HISTORIC AND DESIGN REVIEW COMMISSION

September 18, 2019

HDRC CASE NO: 2019-516
ADDRESS: 219 E HOUSTON ST
LEGAL DESCRIPTION: NCB 407 BLK 17 LOT E 93.51 FT OF 19 COURT BUILDING SUBD
ZONING: D, H, RIO-3
CITY COUNCIL DIST.: 1
LANDMARK: Wright Building
APPLICANT: Fernando Ramirez
OWNER: GRAYSTREET HOUSTON-219 E HOUSTON STREET LLC
TYPE OF WORK: Patio fencing installation
APPLICATION RECEIVED: August 27, 2019
60-DAY REVIEW: October 26, 2019
CASE MANAGER: Edward Hall
REQUEST:

The applicant is requesting a Certificate of Appropriateness for approval to install a four (4) foot tall wrought iron patio fence at 219 E Houston.

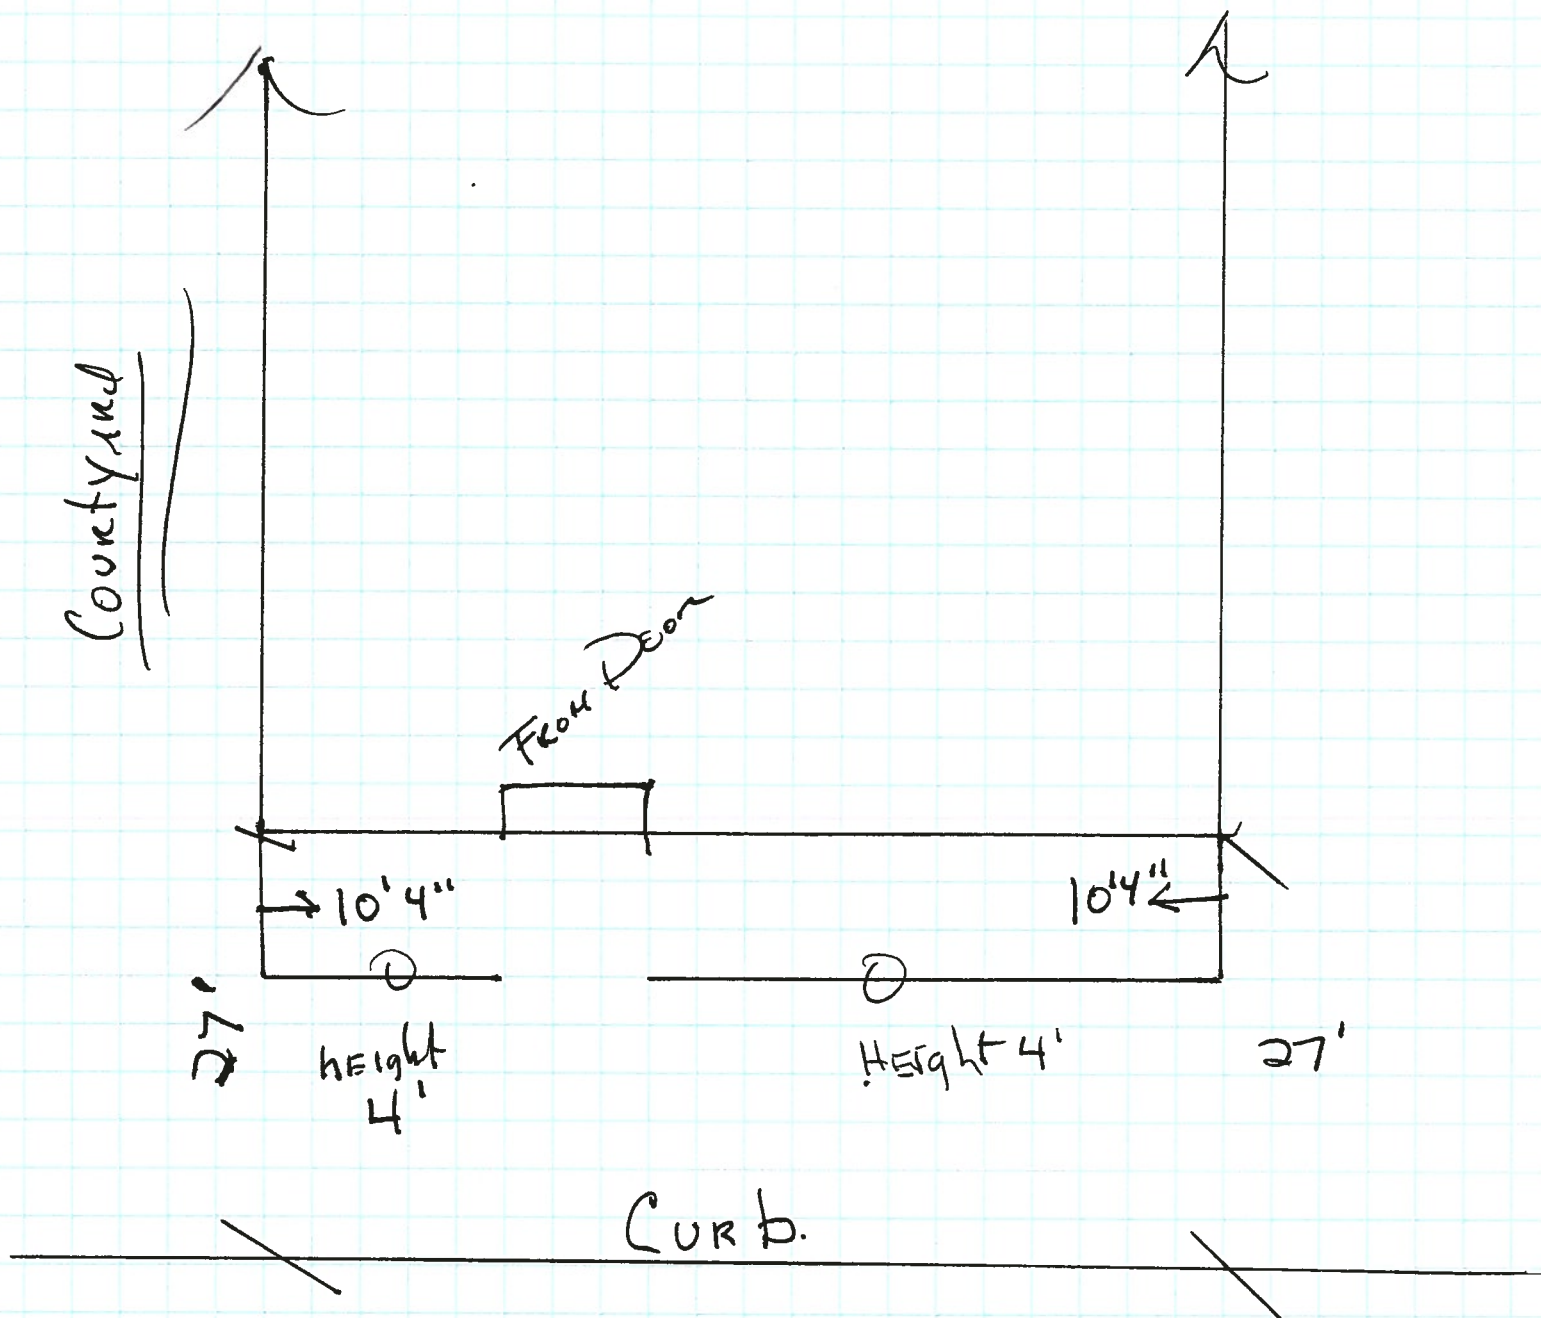
- 1.) 4' WROUGHT IRON FENCE
TO BE SAME AS TH. PALMA
AND THE HOTEL (GUEYTHEN)

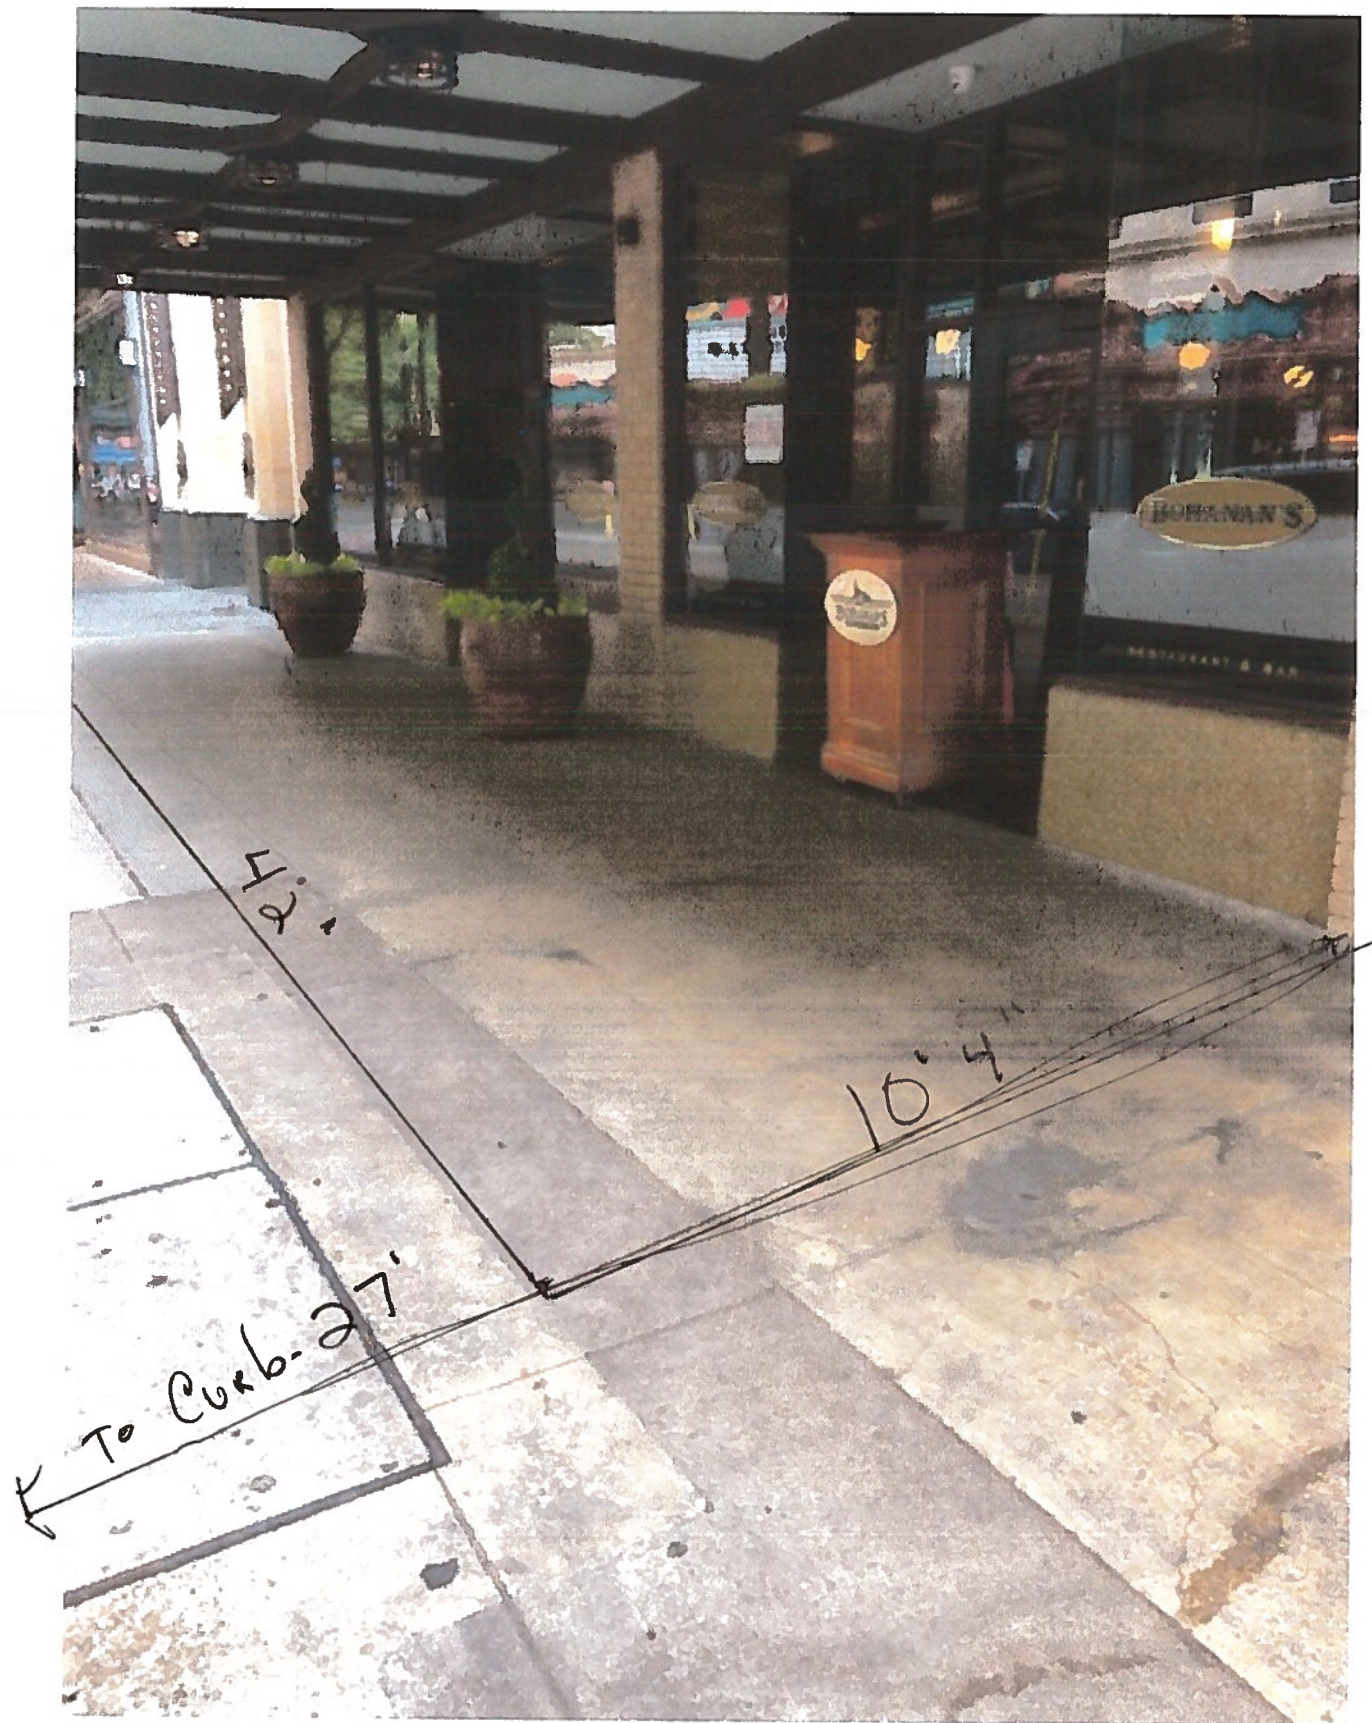
the PALM'S FENCE
which WE WILL COPY
